## ATTACHMENT A

**PROJECT:** Old Georgetown Road (MD187)//West Cedar Lane/Oakmont Avenue Intersection  
SHA Contract No. MO5935370  
Mandatory Referral No. MR2010805

#### Proposed Configuration

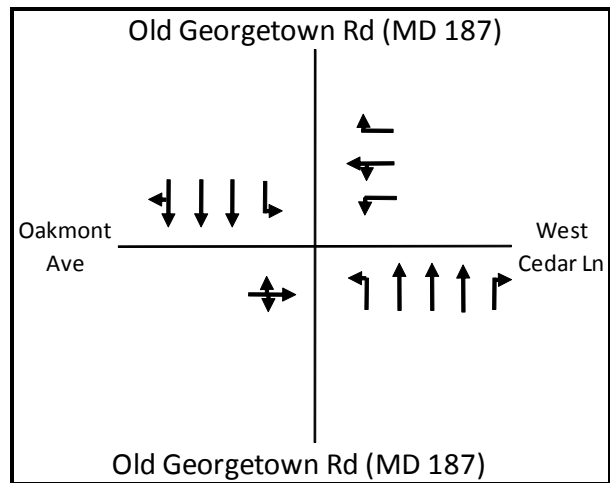
**Old Georgetown Road (MD187):** The project is consistent with the Master Plan in regard to the number of lanes and the provision of a shared-use path on the east side of the roadway. The project is not consistent with the Master Plan recommendation for trees in the median and along both sides of the road.

**West Cedar Lane:** The proposed pavement width exceeds the recommended 48 feet for a distance of about 300 feet east of the MD187 intersection. The proposed shared-use path is consistent with the Master Plan.

Two segments of the proposed sidewalk on the west side of Old Georgetown Road (MD187), with a total length of about 600 feet, and a 100-foot length on West Cedar Lane do not meet the AASHTO recommendation to be two feet wider where immediately adjacent to the roadway curb to provide a greater measure of pedestrian safety and comfort.

AASHTO recommends that a pedestrian refuge island be considered where the crossing distance is greater than 60 feet. The crosswalk on the south leg of MD187 is approximately twice that length without a refuge and is therefore inconsistent with AASHTO’s guidance.

The proposed sidewalk on the west side of Old Georgetown Road (MD187) does not meet the ADA Best Practices described in Appendix E-1, since its location adjacent to the curb would require that it be warped at every driveway. All pedestrians would be required to negotiate fourteen ramps to travel along the sidewalk between Oakmont Avenue and Center Drive, an average of one ramp for every 46 feet of sidewalk. This would be an annoyance for an able-bodied pedestrian, but would require a lot more extra effort from people with a mobility disability and could create problems for those with visual impairments also. We recommend that the sidewalk be offset from the curb, and discuss additional reasons in Landscaping below.

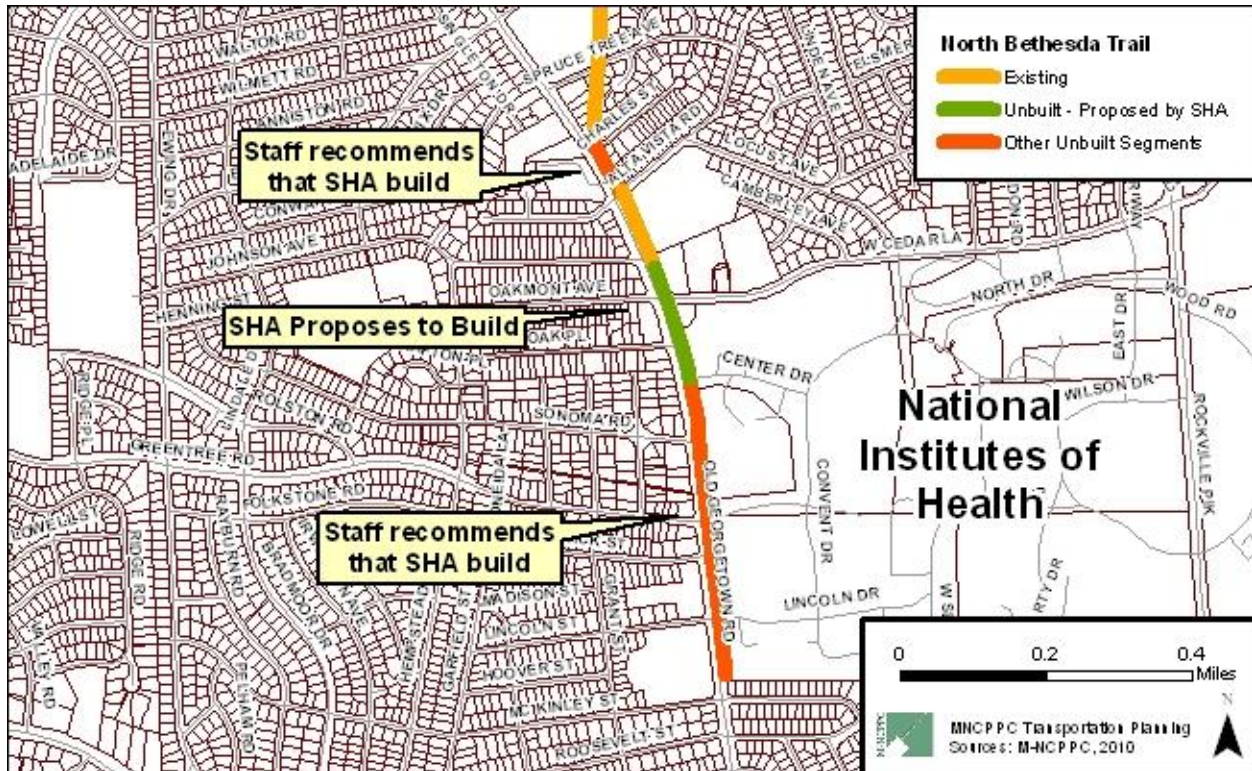
As noted above, the crosswalk on the south leg of MD187 does not have a pedestrian refuge, but at 118 feet long, is almost twice the length (60') at which one should be considered. Since left turns are proposed to be allowed from two lanes of West Cedar Lane (westbound to southbound), there is sufficient room to extend the median and provide a refuge without causing conflicts with trucks making the left from the center lane if the crosswalk is angled to be more perpendicular to the west curb of MD 187. We recommend that the refuge be reconsidered, even if it means restricting larger trucks to the center lane on West Cedar Lane. Guide striping for left turning vehicles could help address turning radius concerns.
